LOT GRADING REVIEW

LOT/BLK. NO.(S) Lot 111
DATE: MAR 31 2017

PROJ. No. 16-12	MUNICIPAL ADDRESS
LOT No. 111

REG. PLAN
PART OF LOT 6 CONCESSION 2, NEW SURVEY
(GEOGRAPHIC TOWNSHIP OF TRAFALGAR)
REGIONAL MUNICIPALITY OF HALTON
20M-1184 TOWN OF MILTON

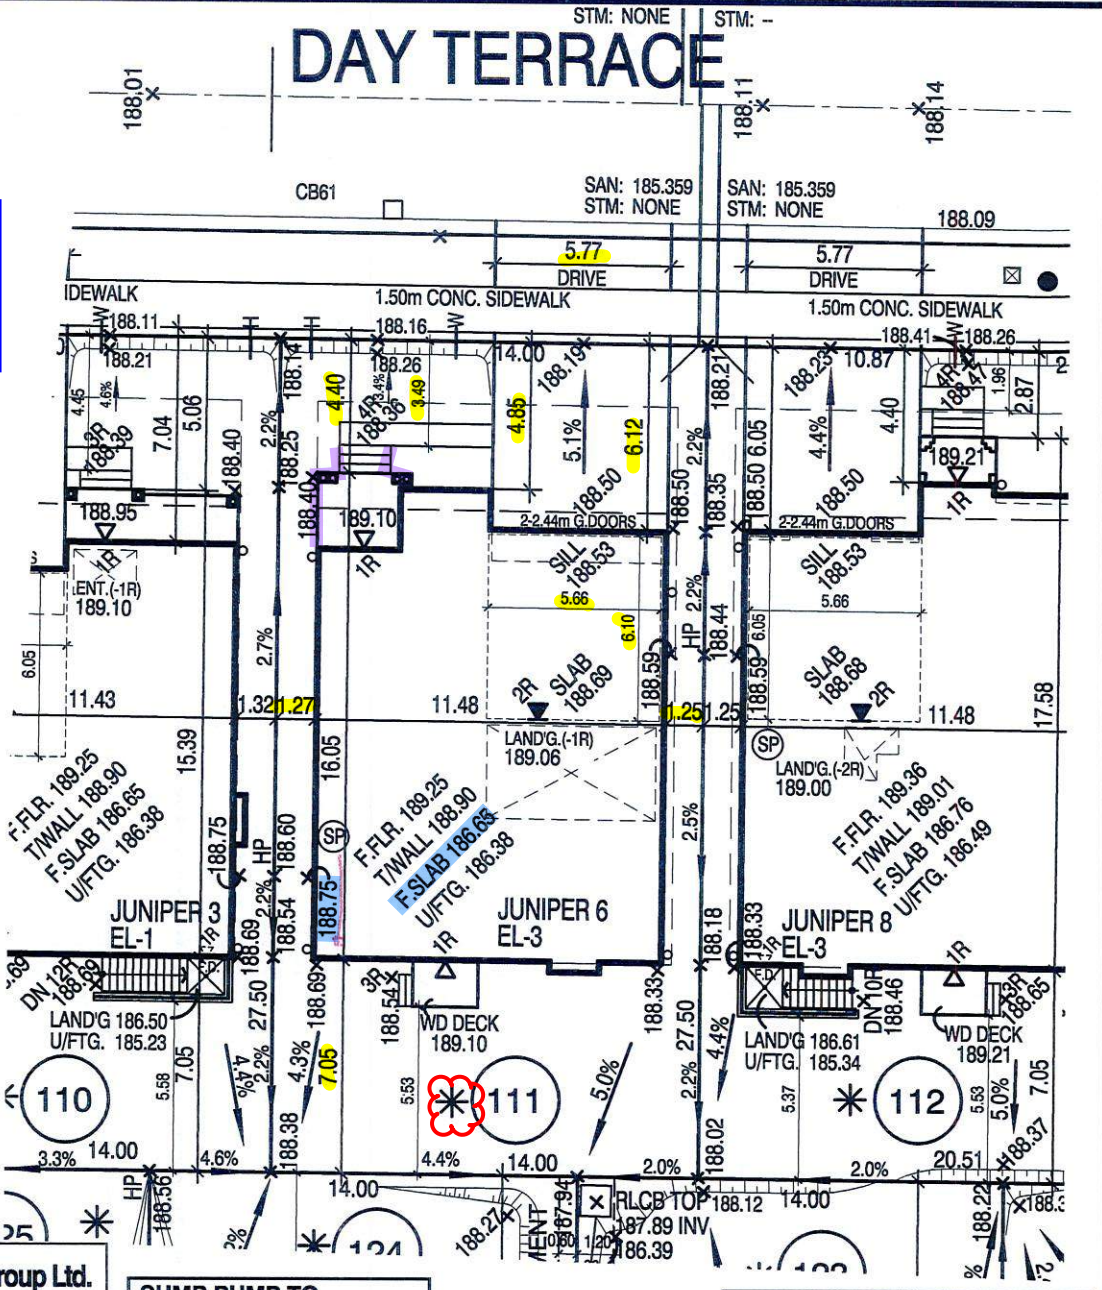
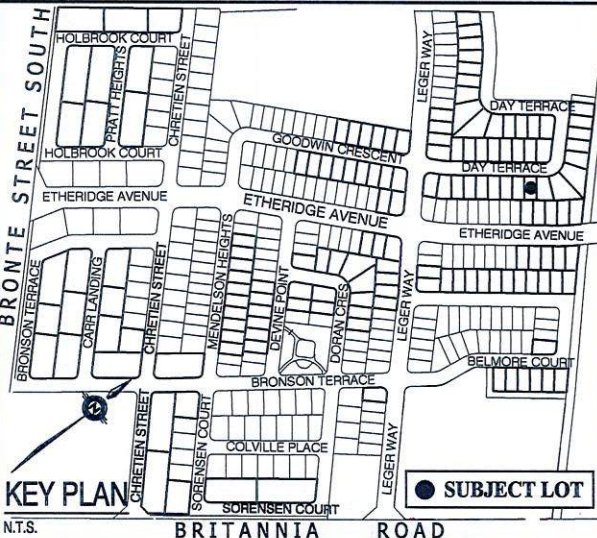
Guard/Handrail as per 9.8.

Backfill height as per 9.15.

Siting to be read in conjunction with reviewed main model drawings

SUMP PUMP TO DISCHARGE TO REAR SPLASH PAD.

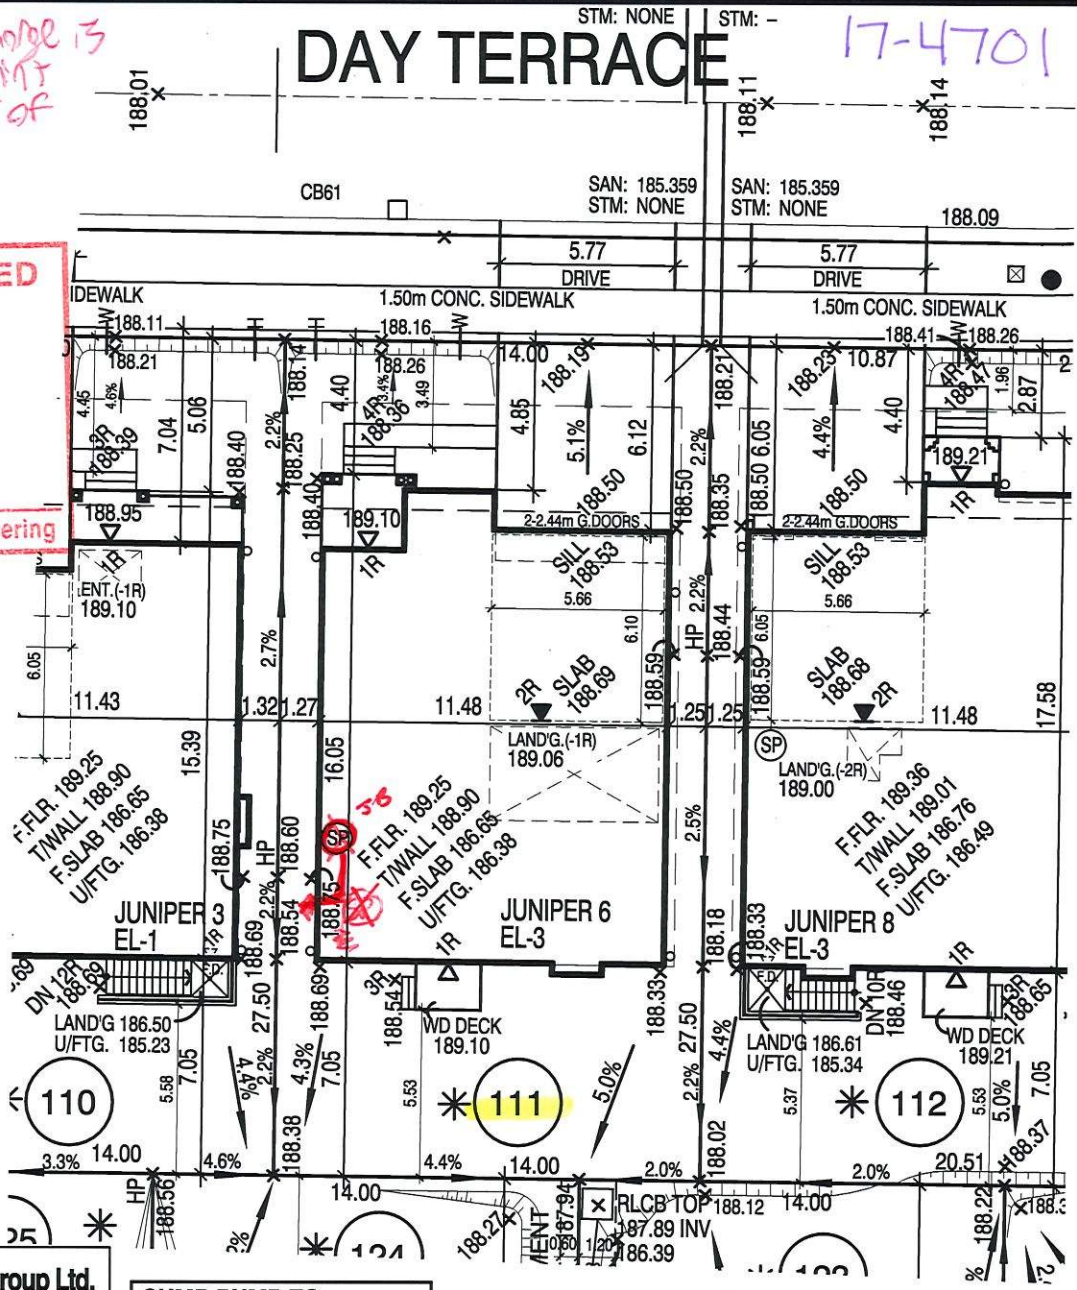
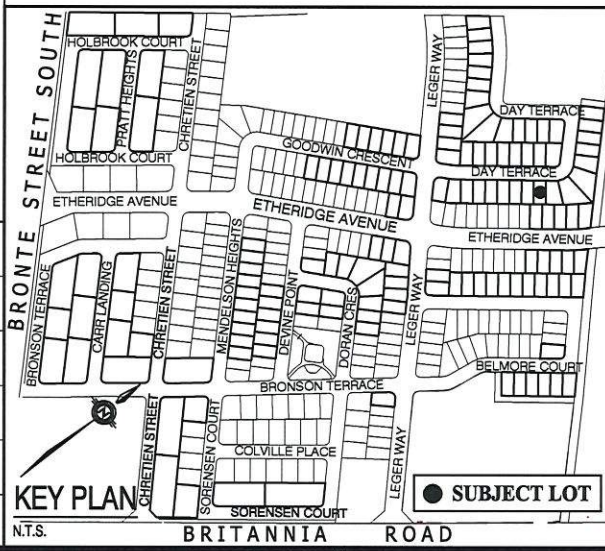
Note: Ensure sump discharge is located past the high point and directed to the rear of the lot.
